<b>AMENDMENT OF SOLICITATION/MODIFICATION OF CONTRACT</b>				1. CONTRACT ID CODE	PAGE 1 OF 3 PAGES
2. AMENDMENT/MODIFICATION NO. AMENDMENT NO. 0003		3. EFFECTIVE DATE 01/31/08	4. REQUISITION/PURCHASE REQ. NO.	5. PROJECT NO. (If applicable) 00-4789	
6. ISSUED BY Resident Officer in Charge of Construction 1005 Michael Road Camp Lejeune, NC 28547-2521		CODE ase	7. ADMINISTERED BY (If other than Item 6) See Item 6		CODE
8. NAME AND ADDRESS OF CONTRACTOR (No., street, county, State and ZIP Code)				(X)	9A. AMENDMENT OF SOLICITATION NO. N40085-00-R-4789
				x	9B. DATED (SEE ITEM 11) 12/31/07
CODE					10A. MODIFICATION OF CONTRACT/ORDER NO.
					10B. DATED (SEE ITEM 11)
FACILITY CODE

00-4789, Major Interior/Exterior Repairs, Building 407

CONTINUATION SHEET

Sketch #1 NTS

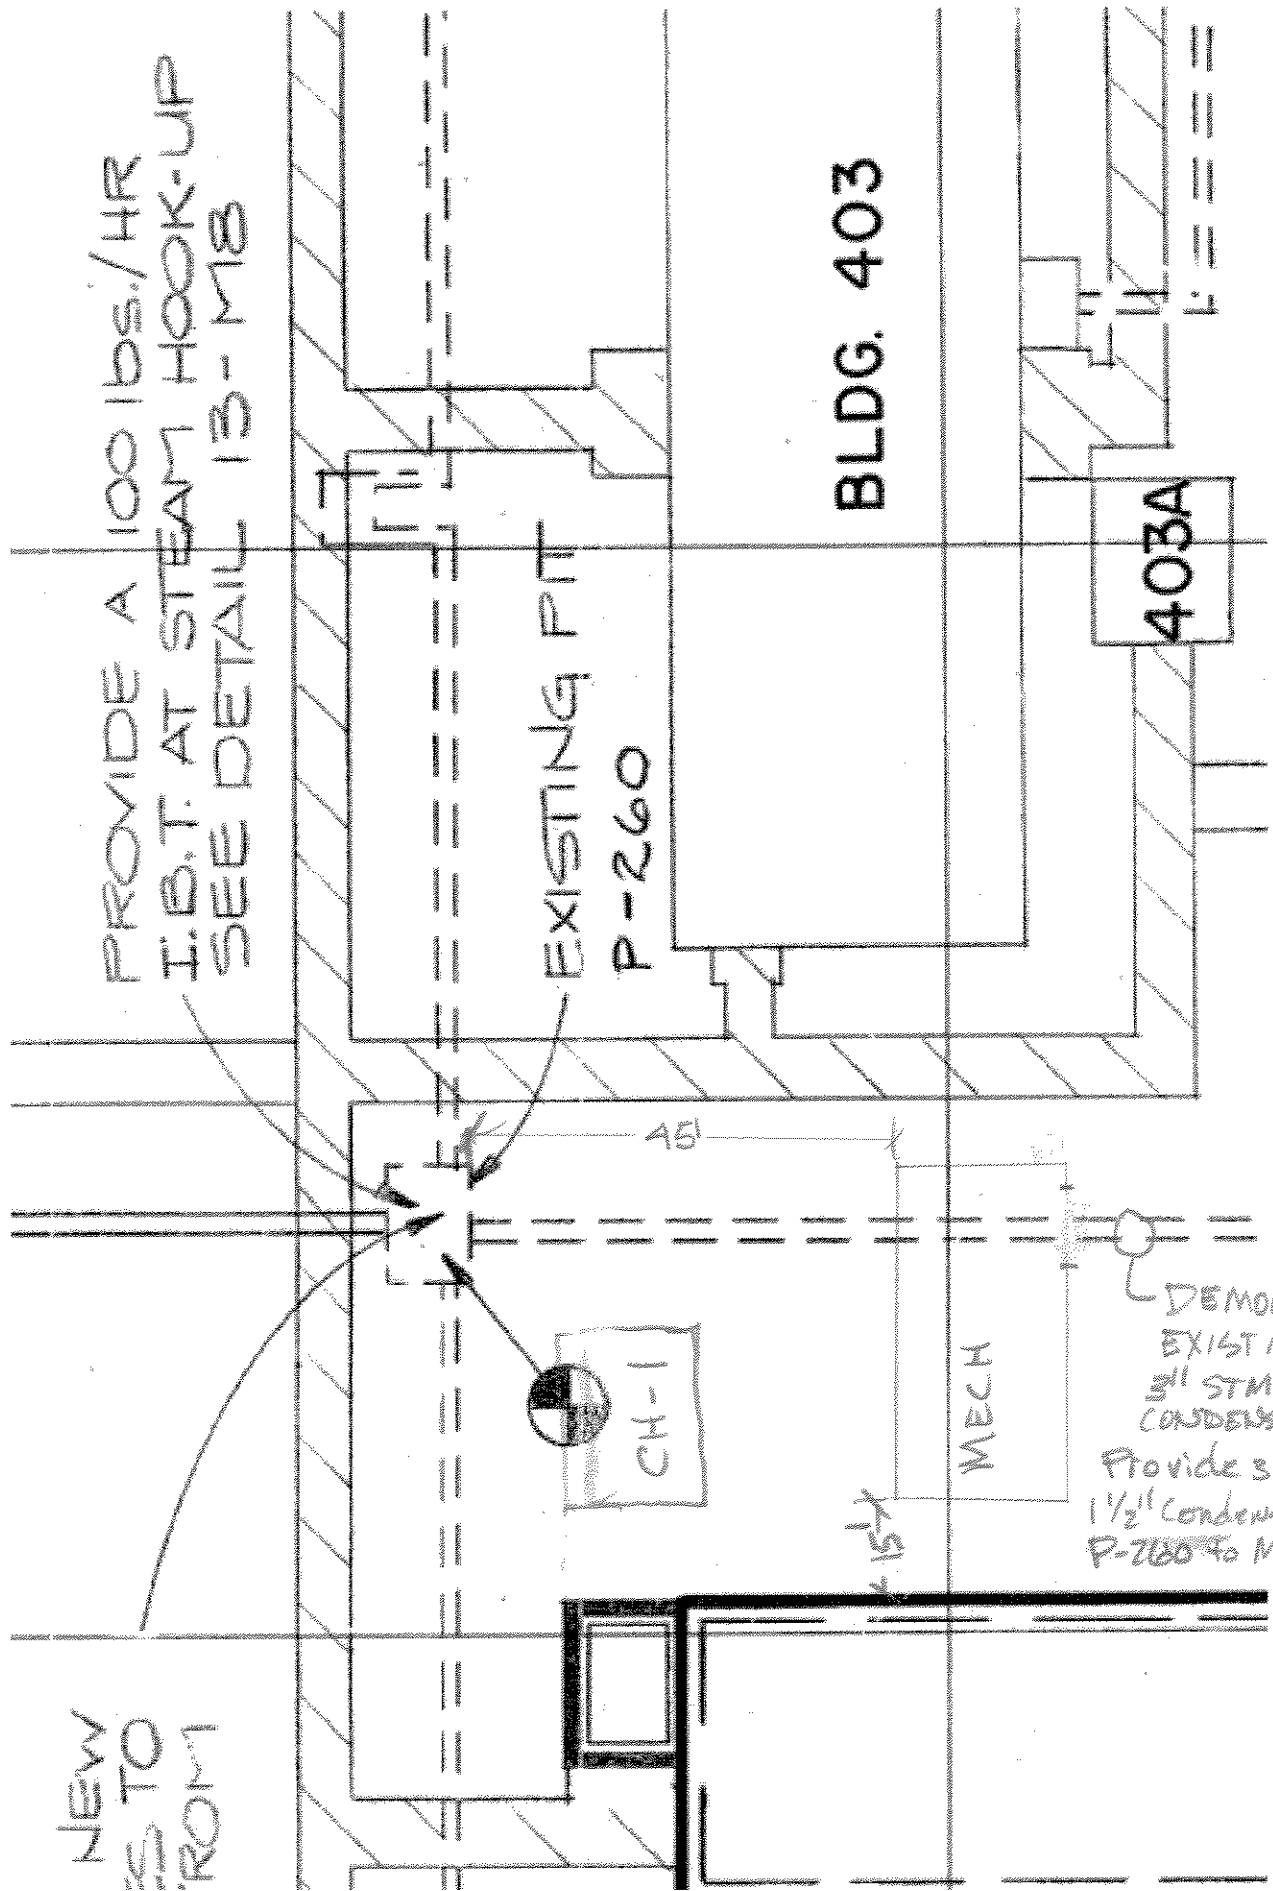
Answer: Provide 3000 PSI grout.
4. On Sheet A1: Delete note 45. On Sheet A3: Delete requirement to provide new stairs A, B, C, and D.
5. On Drawing A-101: Delete notes 32, 35, 36, 41, 42, 43, 47, 48, 50 and 51.
6. Spec Section 23 21 13.00 20, Delete paragraph 3.4.2.
7. Spec Section 23 22 00.00 40, Delete paragraphs 3.2.1 & 3.2.2.
8. Spec Section 23 22 26.00 20, Delete paragraph 3.1.5.
9. Spec Section 23 64 26, Delete paragraphs 2.11 through 2.11.6.7
10. Spec Section 23 64 26, Delete paragraph 3.5.
11. Remove all mastic under all floor coverings as asbestos containing material.
12. Sheet A-103: Add to end of Note 12 – ‘Typical of all sidewalk areas with no other note applied.’
13. Incorporate the attached Sketch into the project/contract.

PROVIDE A 100 lbs./HR  
I.B.T. AT STEAM HOOK-UP  
SEE DETAIL 13-M18

DEMOLISH  
EXISTING  
3" STM 1/2"  
CONDENSATE  
Provide 3" STM  
1/2" Condensate  
P-260 to Mech
